**Pacific Gas and  
Electric Company**

PG&E Letter DCL-00-126

Docket No. 50-275, OL-DPR-80  
Diablo Canyon Unit 1  
Response to NRC Request for Additional Information Regarding License  
Amendment Request (LAR) 99-03, Unit 1 Reactor Core Thermal Power Uprate

## **PG&E Response to Request for Additional Information For Diablo Canyon Power Plant (DCPP) Unit 1 Power Uprate**

Figure 2-1  
Model 51 Steam Generator Moisture Carryover

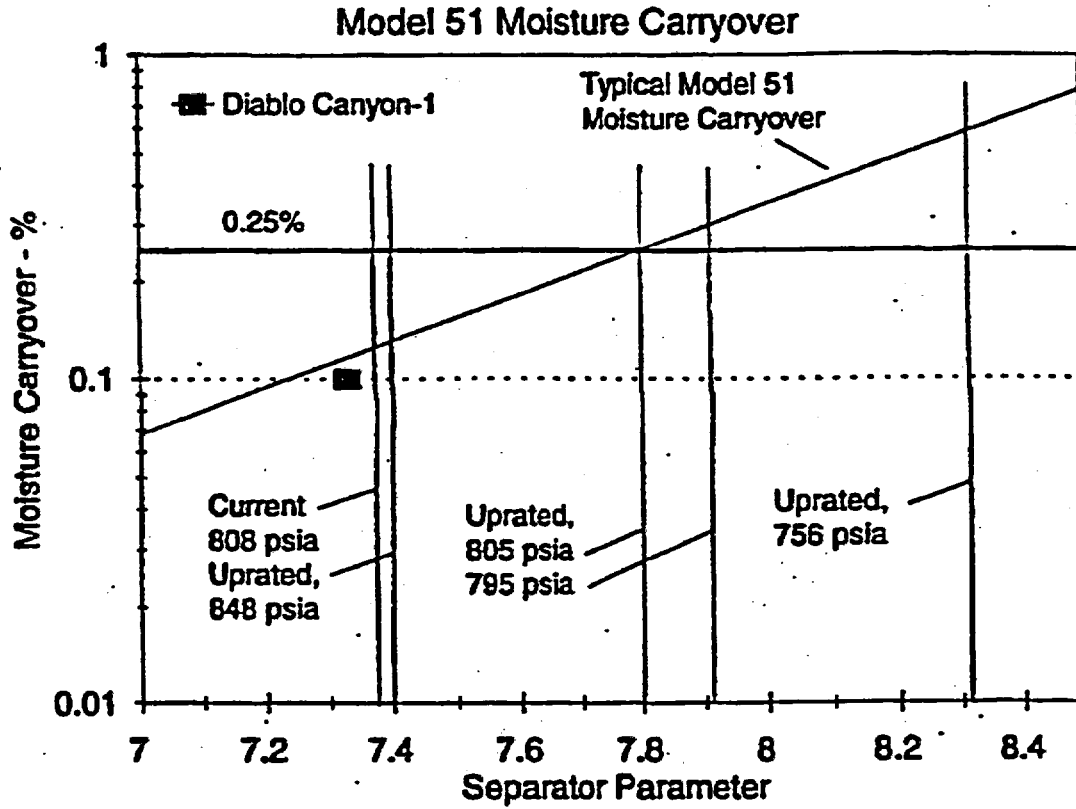
*In Section 5.1.2, you stated that the replacement interval for the SG manway is reduced from 34 years to 31 years for operation at the uprated conditions. Please confirm that the plant procedures will be revised to incorporate the 31-year replacement interval for the SG manway bolts prior to the implementation of the power uprate. Also, provide an evaluation of the flow-induced vibration of the SG U-bends tubes and moisture carryover due to power UPRATE regarding the analysis methodology, vibration level, computer codes used in the analysis and the calculated elastic-fluid instability ratio.*

Figure 2-1 plots the trend of moisture carryover versus separator parameter for two plants with the same separator package as DCP Unit 1. This trend is followed by all Model 51 SGs with this package, although the scatter of individual moisture measurements is significant. Also plotted on this figure is the single available moisture measurement made at DCP Unit 1. This value is seen to be close to the trend line plotted. The vertical line, identified as the current rating at a steam pressure of 808 psia, represents the present full power operating point in terms of the separator parameter. The expected and measured moisture carryover are near 0.1 percent.

To determine the expected values of moisture carryover at the uprated power, vertical lines are drawn on Figure 2-1 corresponding to the operating assumptions, which determine the value of steam pressure. The line on the far right corresponds to the uprated design condition with a low steam pressure resulting from assumptions of high fouling and plugging levels. The moisture carryover for this case will significantly exceed 0.25 percent. On the far left, the uprated operating point corresponds to best estimate assumptions with regard to fouling and plugging. The high steam pressure causes the separator parameter to remain near current levels even with the increase in power. The moisture will also remain near the current value of 0.1 percent. If the plant is operated at a primary  $T_{avg}$  reduced by 5.5°F, a steam pressure of 805 psia is expected and the separator parameter will take on an intermediate value; the moisture level could be expected to be near 0.25 percent. Increasing power but maintaining  $T_{hot}$  at the current operating value will result in a slightly lower steam pressure, 795 psia. At this pressure, the moisture could exceed 0.25 percent, but only slightly.

The analysis has indicated that the moisture separator performance will be a function of the steam pressure at which the plant is operated. As shown in Table 3 of the introduction, the best estimate projected steam pressure for the planned Unit 1 uprated full power programmed reactor coolant system (RCS)  $T_{avg} = 573.49^\circ\text{F}$  is about 795.2 psia which should maintain the SG moisture carryover near a value of 0.25 percent. However, DCP will be performing a test after Unit 1 achieves steady state conditions at the new uprated full power to measure the moisture carryover. If it is determined that the moisture carryover exceeds the desired limit of 0.25 percent in one or more SGs, DCP has several options which can be pursued. These include increasing the full power RCS  $T_{avg}$  and associated steam pressure and/or performing separator repairs as necessary during the next refueling outage. In addition, Westinghouse has developed modifications for the separator systems which have been field tested over the complete range of operating conditions considered in this analysis and could deliver a moisture carryover of less than 0.15 percent over the range of all Unit 1 uprate conditions.
